Memorandum Item: CNCL-24-46

File: Z-2022-11, S-O-2022-04

Re: **Response to Letters Received from Maxwell Heights Neighbourhood Association with respect to Revised Applications to Amend the Zoning By-law (File: Z-2022-11) and for Approval of a Proposed Draft Plan of Subdivision (File: S-O-2022-04)**

**Schedule 'A'
Pinecrest Land Use
and Road Plan**
Part II Plan for the
Pinecrest Planning Area

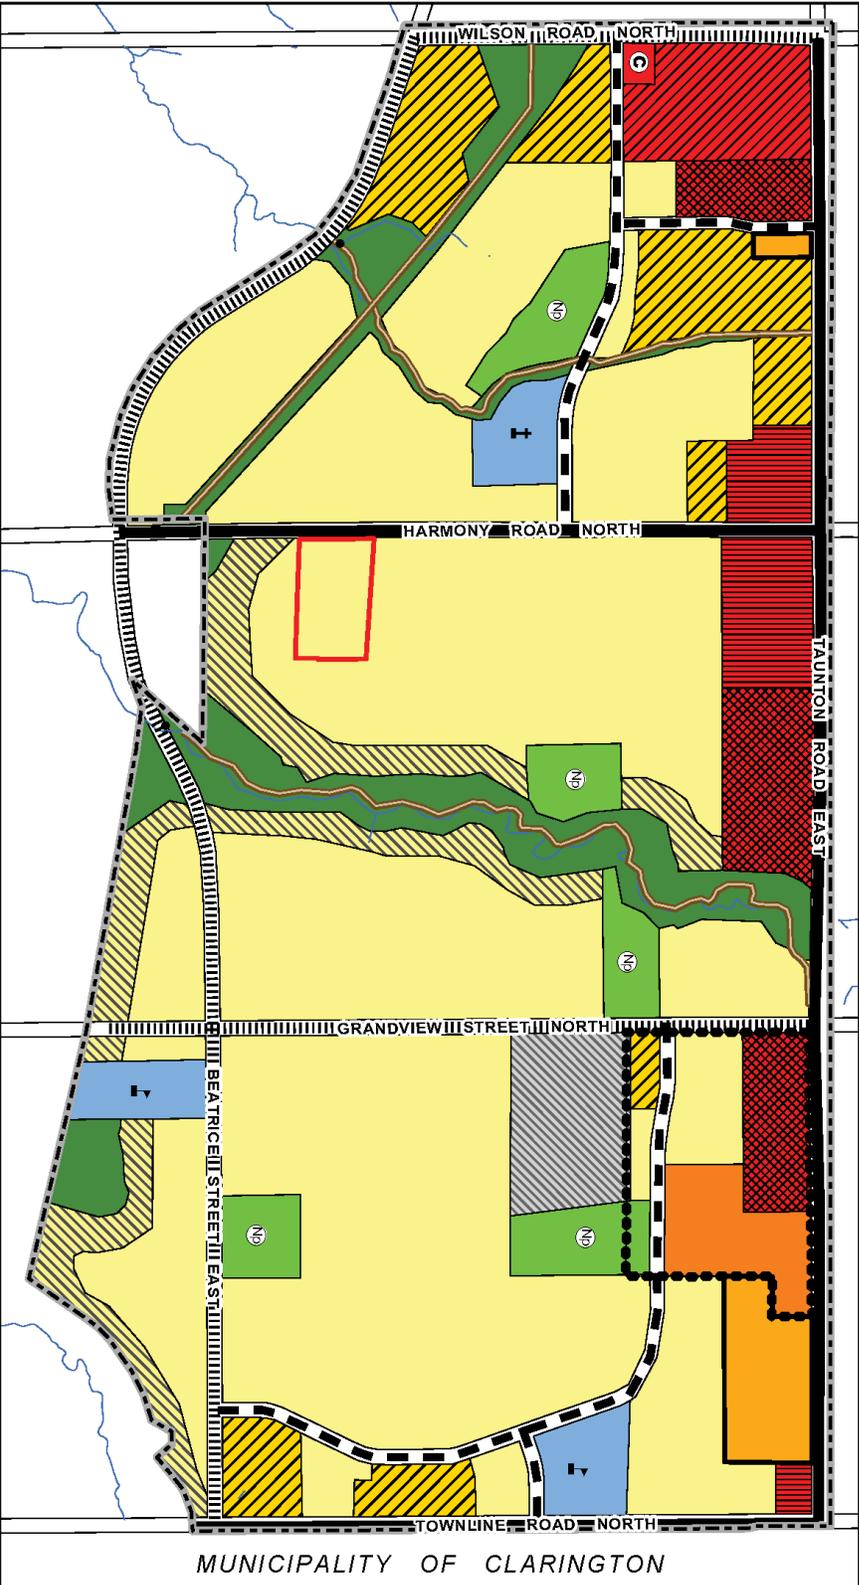
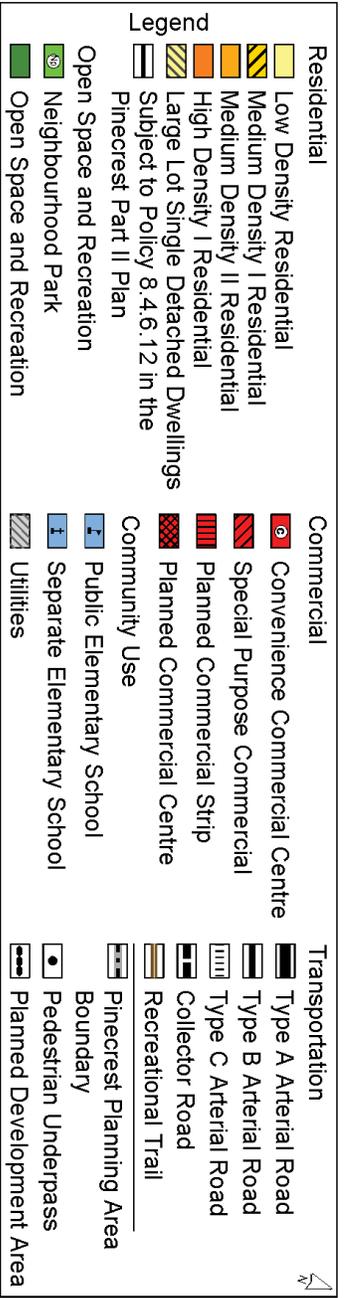
- a) 8.4.6.7 It is the intent of the City to encourage the development of large lot single detached dwellings in areas as schematically shown on the Pinecrest Land Use and Road Plan, particularly where such areas abut creek valleys, woodlots or the top of the slope associated with the former Lake Iroquois shoreline.

- a) Attachment 2 of Report ED-24-42 is a copy of the Pinecrest Land Use and Road Plan which shows areas designated as Large Lot Single Detached Dwellings. This designation applies to various properties in the Pinecrest Planning Area that directly abut open space corridors and creek valleys, as outlined in Policy 8.4.6.7 of the Pinecrest Part II Plan. Lands on the east and south sides of Pinecrest Road and the east side of the north-south leg of Swiss Height have been developed as large lot single detached dwellings. This designation does not apply to the Subject Site.
